DEVIATION REQUEST AND DECISION FORM

Project Name : Urban Collection at Palmer Village
Schedule No.(s) : 5405100041, 5405100042, 5405100043, and 5405100044
Legal Description : See Attachment #1

A deviation from the standards of or in Section **Section 2.3.7.F.1 Curb Returns – Radii, Table 2-31** of the Engineering Criteria Manual (ECM) is requested.

ORIGINAL SCALE: 1" = 60'
AUTOTURN FIRE TRUCK
EXHIBIT – EAST SIDE
EAST THROUGH SITE
PALMER VILLAGE
JOB NO. 25149.01
04/20/2020
SHEET 2 OF 3

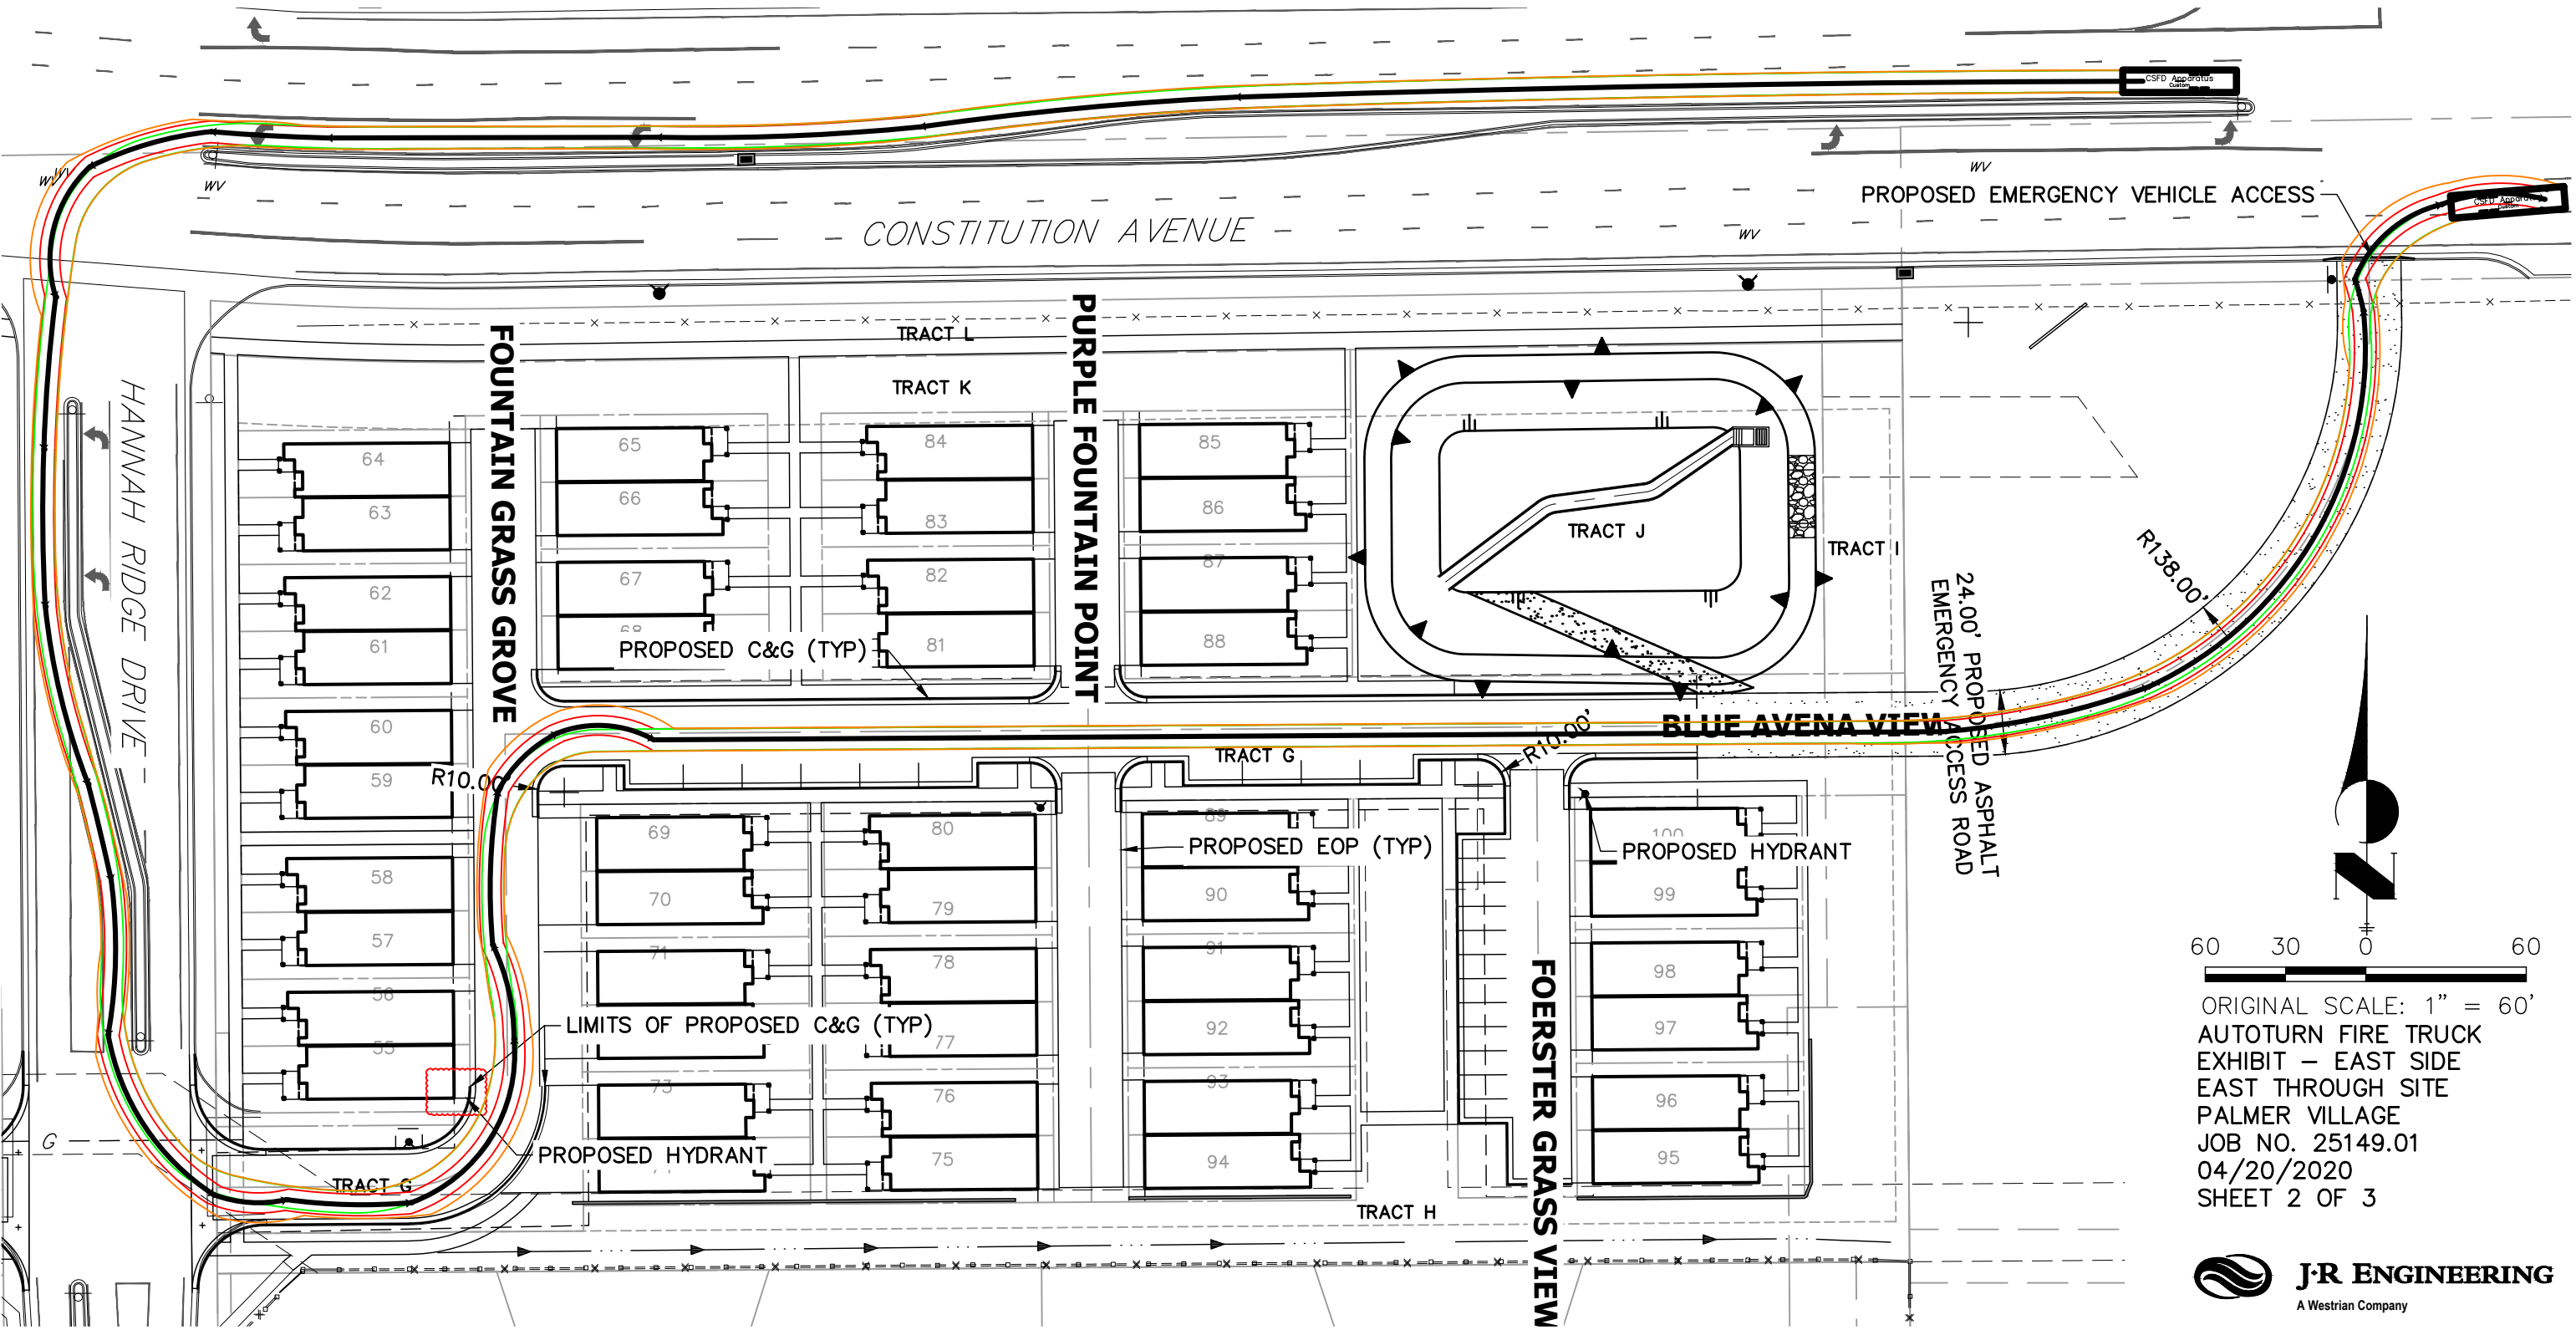
The private roadway network of the development will function and be laid out as alleys off of Hannah Ridge Drive. The County criteria does not address alleys. The development requires parking for the units to be along the roadway, therefore the tighter radii will facilitate maximizing available parking areas. Turning templates have been evaluated for fire and trash trucks. These are shown in Attachment 3.

Access into the alleys (private), and through the intersections will not be impeded by the reduced curb return radii. Turning templates have been evaluated for fire and trash trucks. These are shown in Attachment 3.

The reduced curb return radii will not adversely affect safety or operation. The reduced radii will facilitate slower speeds and require increased awareness by motorists entering or leaving an intersection (alley). Turning templates have been evaluated for fire and trash trucks. These are shown in Attachment 3.
